GLAST Large Area Telescope: AntiCoincidence Detector (ACD)

Critical Design Review (CDR)

January 7 & 8, 2003

Status of January Review Recommendations

Prototype tile for the lowest row of the ACD. Testing shows that this design exceeds the 0.99 efficiency requirement.

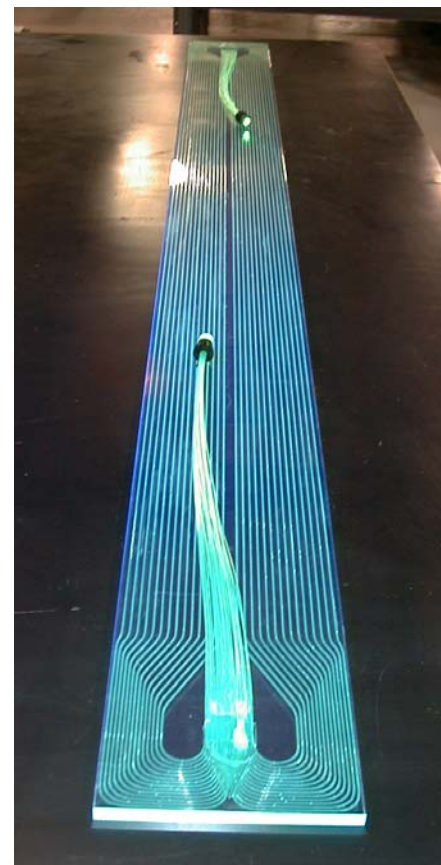
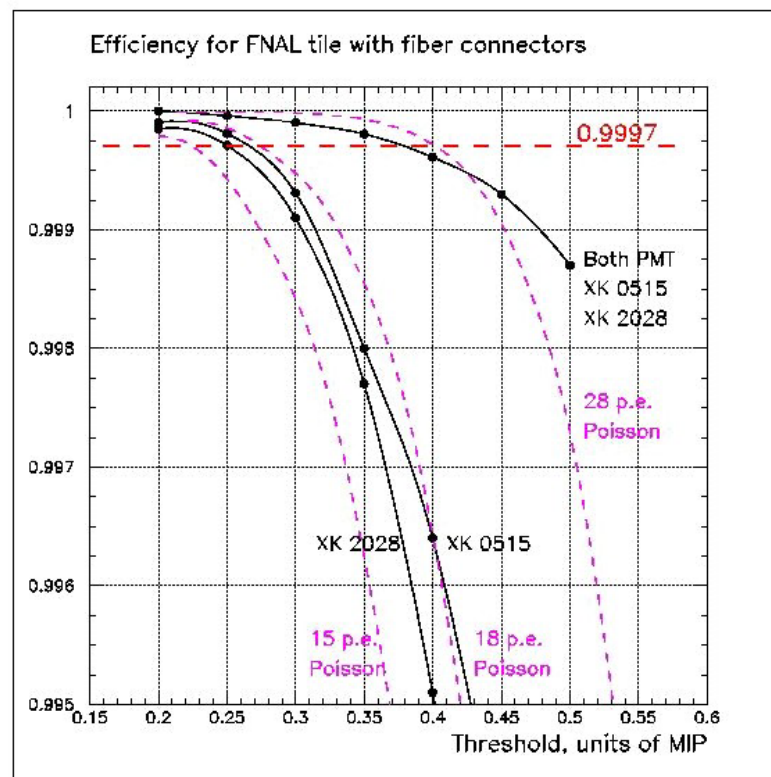
1. Finalize the design and generate the engineering drawings for the tile and fiber layout, including the lowest row of the ACD.

- Designs for the 12 types of tile have been analyzed for thermal and vibration tolerances. Results are being used to generate engineering drawings.
- Design for the lowest tile row has been tested and shown to exceed the requirements.
- Drawings have been made for the routing of the fibers from the tiles to the phototubes. The routing has been checked using a mock-up of the ACD

**LAT-TD-00858-D1, ACD TDA
Thermal Cycling Test**

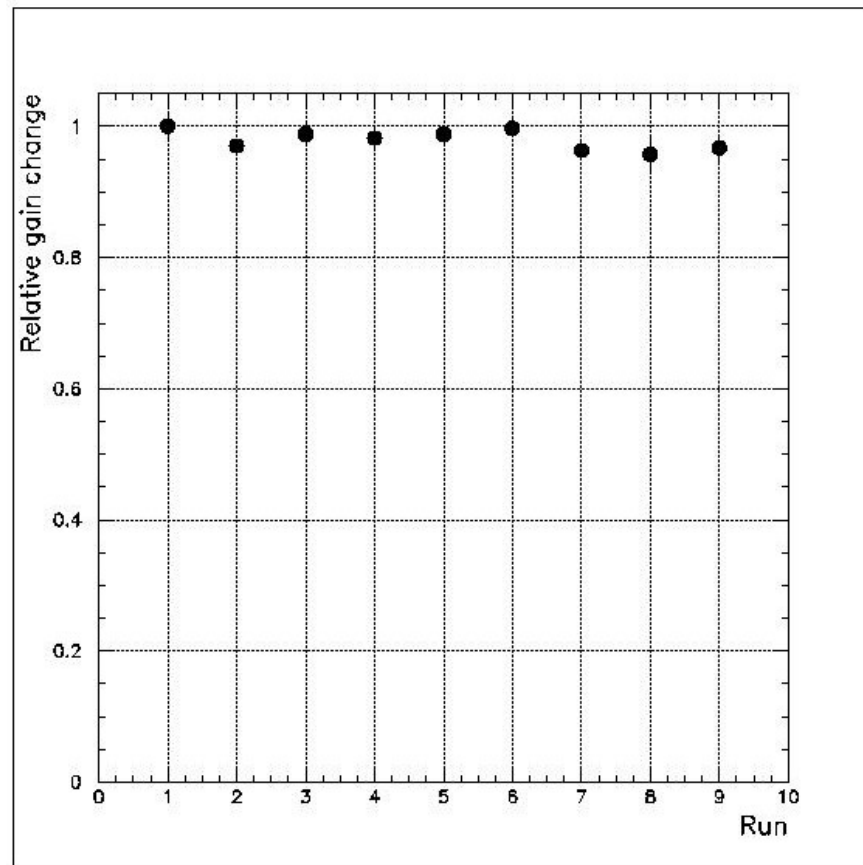
5. Perform thermal cycle of fully assembled tiles and ribbons. Verify that no damage to tile/fiber assemblies takes place and light yield is not decreased.

- Thermal cycle was -65 C to +45 C.
- Performance was measured using a muon telescope for Minimum Ionizing Particles.
- After > 340 cycles, the loss of performance was less than 5%.

Light yield of Tile/fiber assembly during thermal cycling.
